Office Action Summary

10/064,605

BUNKER, RONALD SCOTT

DETAILED ACTION

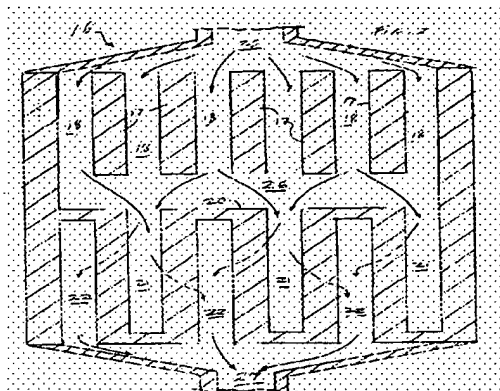
Figure 2 below depict the flow field plate comprising a base plate; and first and second side plate structurally connected to the ends of the base plate. The base plate includes ribs 17 defining flow-through flow field channels 18, and a serpentine rib 20 that defines inlet channels 21 and outlet channels 22 (SECTION 0013). It is also disclosed that the hybrid flow channels may be implemented in a flow field which folded one or more times (SECTION 0006). *Thus, if the channels are folded, the resulting plate structure will have channels laying one over another.*

Margiott also discloses a plurality of ribs 17 that project from the flow field plate and form recesses or indentations on the plate surface (SECTION 0013/ FIGURE 2). *Therefore, the ribs themselves also act as the claimed concavities.*

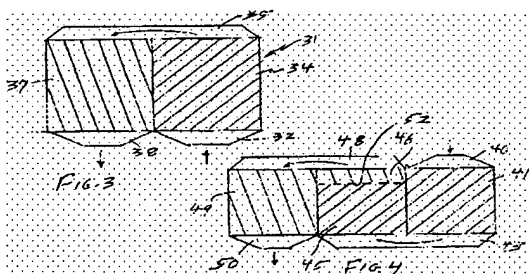
Figures 3-4 below illustrate the flow field plate in a folded configuration in which the oxidant enters through an inlet manifold 32, passes through a portion 34 of the plate having channels, then is turned by a flow reversing manifold 35 so as to flow through a portion 37 of the plate 31 which also has channels (SECTION 0014). In particular, Figure 4 shows the transition between the portions 34 and 37 not at the manifold 35 but mid-way between the manifold 35 and either of the manifolds 32 or 38 (SECTION 0014).

Hence, Margiott's flow field plate comprises a plurality of upper ribs and a plurality of bottom ribs forming top channels and bottom channels in the flow field plate per se to allow a flow of fluid to alternate between the top channels and the bottom channels.

Figures 3-4 above illustrate flow fluid plates in folded configurations wherein the flow reversing manifold or the transition between the plate portions and the flow-through flow field channels and the interdigitated flow field channels are disposed at the angle of substantially 90 degrees to provide the turns or reversing manifolds.
